Report of the Working Party on General Safety Provisions on its 104th session (15–19 April 2013)

Addendum 1

Draft amendments to Regulation No. 107 (para. 6)

Draft 06 series of amendments to Regulation No. 107

"Figure 23

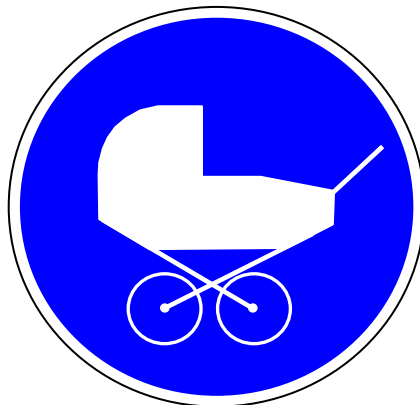
Figure 23, amend to read:

ACCESSIBILITY SYMBOLS

(see Annex 8, paragraphs 3.2.8., 3.6.6. and 3.10.4.)

Model A

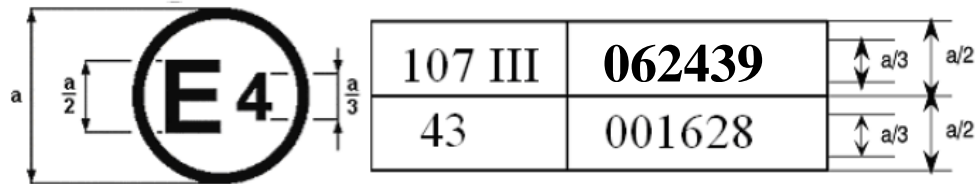
Annex 2, amend to read:

a = 8 mm min

The above approval mark under approval number **062439**. The approval numberas amended by the **06** series of amendments.

The above approval mark Regulation No. 107 included the **06** series of amendments and Regulation No. 43 was in its original form.

The above pursuant to Regulation No. 107 under approval number **062439**. The approval number indicates as amended by the **06** series of amendments."
